Work Order ID 131737

Item Name: Quick Release Heli-Utility-Basket™ Long, HD Lid, Spacepod™/Squirrel Cheek Comp.

DART SERVICE INSTRUCTION

TO AMEND INSTALLATION INSTRUCTIONS D350-607-3 Rev.D,
INSTALLATION INSTRUCTIONS D350-607-4 Rev. C AND
INSTRUCTIONS FOR CONTINUED AIRWORTHINESS ICA-D350-607 REV. 6
REF TCCA STC: SH94-14
REF FAA STC: SR00213NY
REF EASA STC: EASA.10016996
REF BRAZILIAN STC: 2007S03-031-041-051-06

FIGURE 1: INSTALLATION OF D4775-041 FWD STRUT

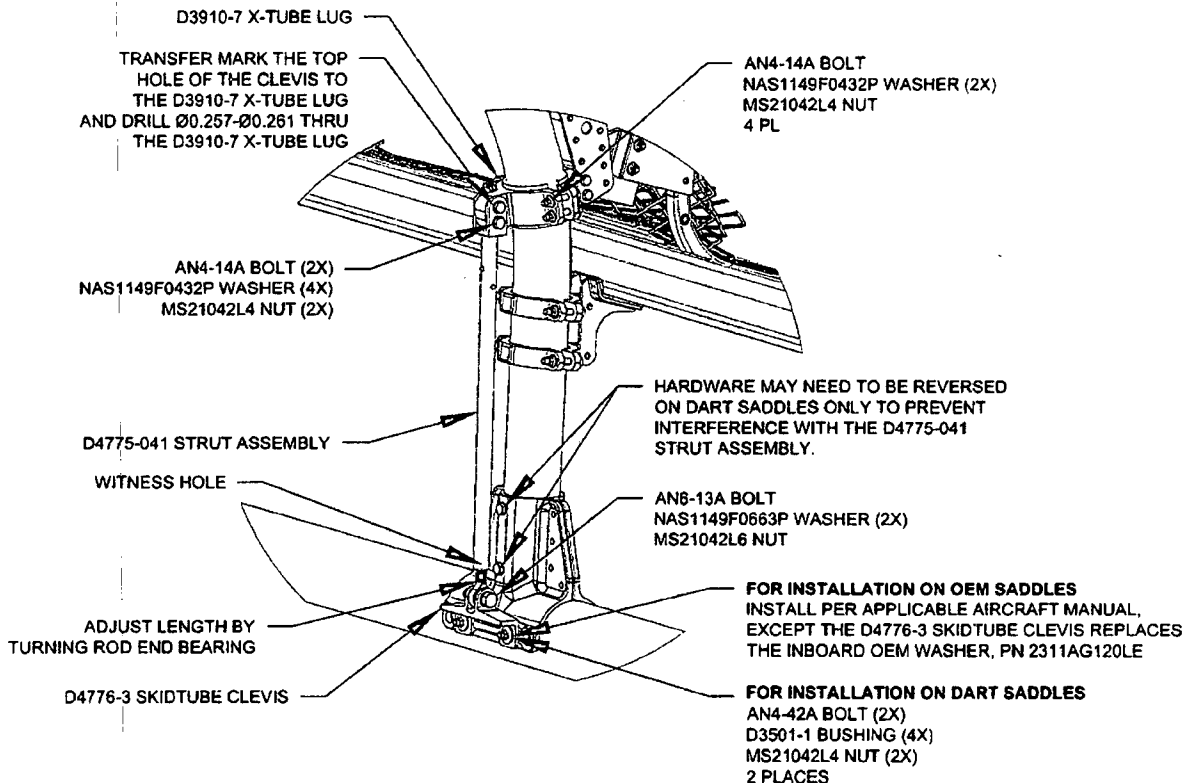
- 3.1 Substitute the Forward Lower D3910-5 X-Tube Lug with the D3910-7 X-Tube Lug as shown in Figure 1.
- 3.2 Install the forward D4775-041 Strut Assembly. Transfer mark from the upper hole on the clevis of the D4775-041 Strut Assembly to the D3910-7 X-tube Lug and drill thru the lug $\varnothing 0.257$ - $\varnothing 0.261$ as shown in Figure 1. Touch up chemical conversion coating per MIL-DTL-5541. Check the witness holes located at the bottom end of the D4775-041 Strut Assemblies to ensure that the thread from the rod end extends past the witness hole.
Torque MS21042L4/-4 nuts to 50-70 in-lbs (5.7-7.9 N-m). Torque MS21042L6/-6 nuts to 160-190 in-lbs (18.1-21.5 N-m).
- 3.3 Complete the installation in accordance with Installation Instructions D350-607-3 Rev. D or D350-607-4 Rev. C.
